# Dascomb Road Traffic Presentation

July 23, 2019

# Peer Review

## *Dascomb Road / Lovejoy Road / Acorn Drive*

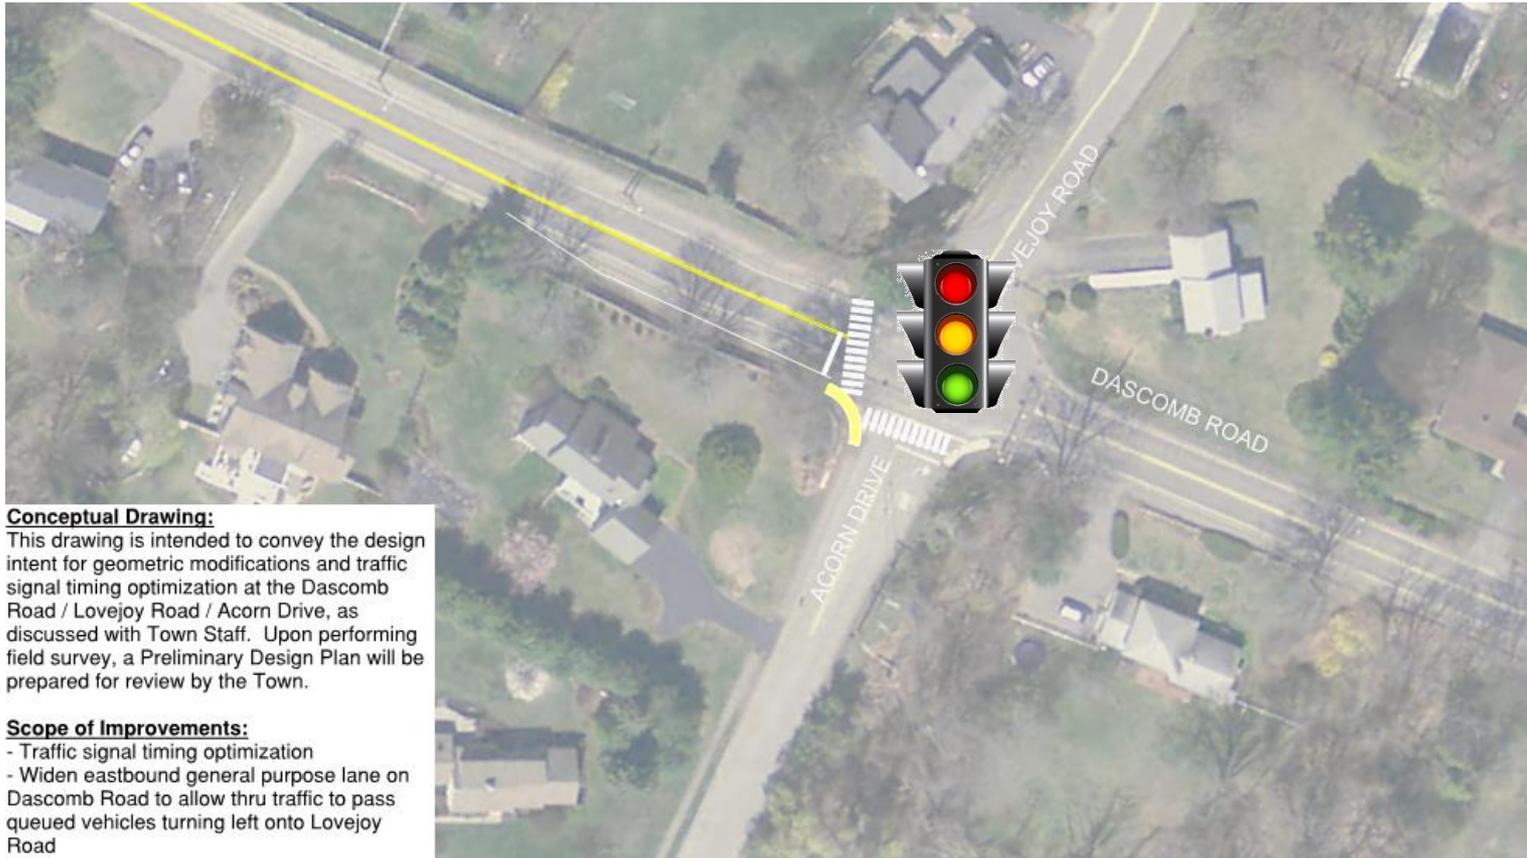
- Traffic signal timing optimization
- Widen eastbound general purpose lane on Dascomb Road to allow thru traffic to pass queued vehicles turning left onto Lovejoy Road

## Comment #18

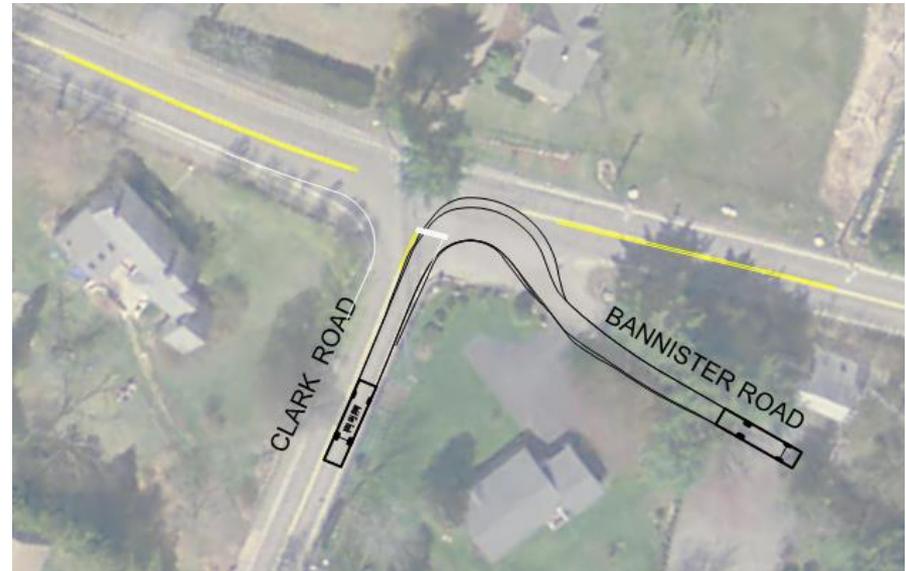
- Review Comment
  - As design of Dascomb Road / Lovejoy Road intersection is advanced into Preliminary Design include dimensions of lane width, length, and taper length. Verify clearance intervals and adjust as necessary when the signal timing is optimized.
- Applicant Response
  - Agree to incorporate recommendations into the Preliminary Design Plan.

## Comment #21

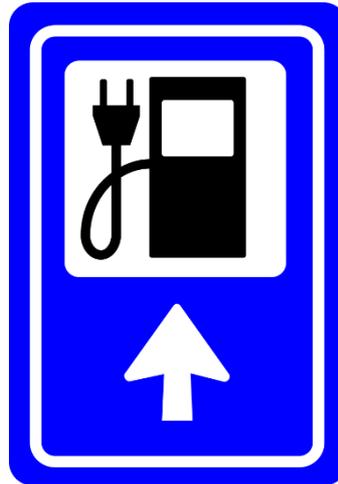
- Review Comment
  - If “banked” parking spaces are to be formalized into paved parking, demonstrate need by conducting a parking utilization study. Then convert parking, if needed, in the following order depicted below.
- Applicant Response
  - We also believe formalizing banked parking won’t be necessary, however, we agree to the process outlined in the letter in the event that additional parking is needed.
